TECHNICAL BULLETIN 025

23/10/2008

GM 1.7D (ISUZU) / SYNCHRONOUS DRIVE / TENSIONER INFO

GATES REFERENCE:
5563XS & related kits.

FIG. 3

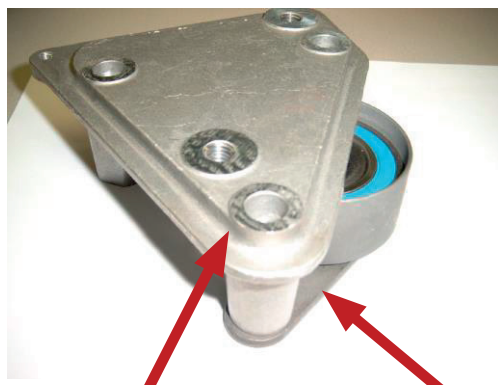
As the initial tensioner base plate was fitted under a leg of the engine support bracket (Fig. 3), K015563XS can only be used from engine nr 328704 on.

FIG. 4

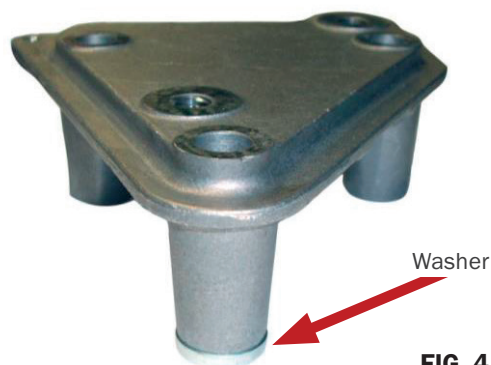
K025563XS is supplied with a washer to compensate the lost thickness of the base plate under the shorter leg of the early engine support bracket as in Fig. 4, and contains a stud which is needed to hook the new tensioner spring on (Fig. 5). This K02 can always be used: up to engine nr 328703, using the washer and the stud; and from engine nr 328704 without the washer and the stud.

11. K025563XS: stick the washer (Fig. 4) on the bottom engine support leg (using fixing glue), in order to avoid losing the washer when loosening the support bracket bolt later. K035563XS: install new bracket.

FIG. 5

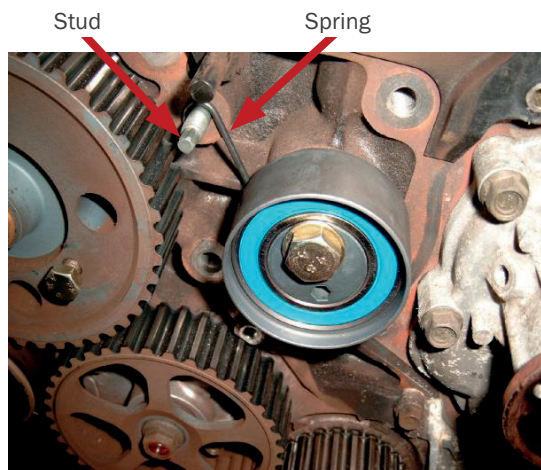
1. Remove the used tensioner, spring, idler and belt.
2. Install the new idler and bolt.
3. Insert and torque (18.6 Nm) the stud at the right hand side of the injection pump pulley (Fig. 5).

FIG. 6

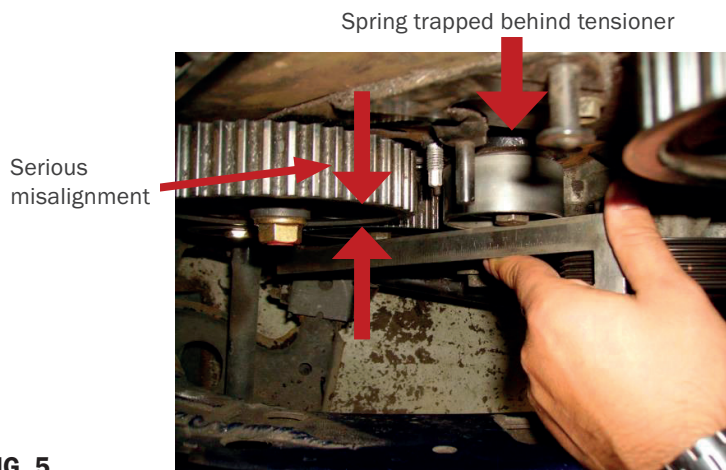
4. Install the new coil spring tensioner (spring over stud, bolt hand tight); make sure tensioner is sitting perfectly against engine block. If not, the spring could end up between the tensioner and the engine block, creating a serious tensioner misalignment (see Fig. 6).

1. Remove the old tensioner, spring, idler and belt.
2. Install the new idler and bolt.
3. Install the new coil spring tensioner (spring over stud, bolt hand tight); make sure the tensioner is sitting perfectly against the engine block. If not, the spring could end up between the tensioner and the engine block, creating a serious tensioner misalignment (see Fig. 6).

FIG. 7

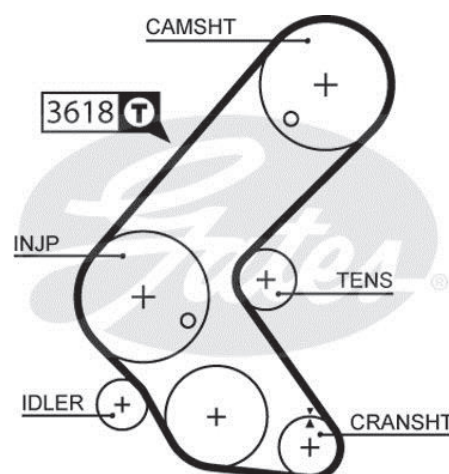
** After completing step 10 of the installation in procedure A), or step 9 in procedure B), it is highly recommended to check the tension in span **T**, (see drive system layout below - Fig. 7) using Gates Sonic Tension Tester STT-1. Enter code 3618 in the STT-1 (ensure chip version 006 is installed) then measure in the normal way. If the tension is too high then the tensioner should be completely released and tensioning procedure repeated until the green light is obtained. If the tension is too low then it will be necessary to assist the tensioner spring with the Allen key; until the green light is obtained.

Failure to observe this procedure could result in the belt tension being too high, leading to an overload on the guide pulley, between the oil pump and injection pump.
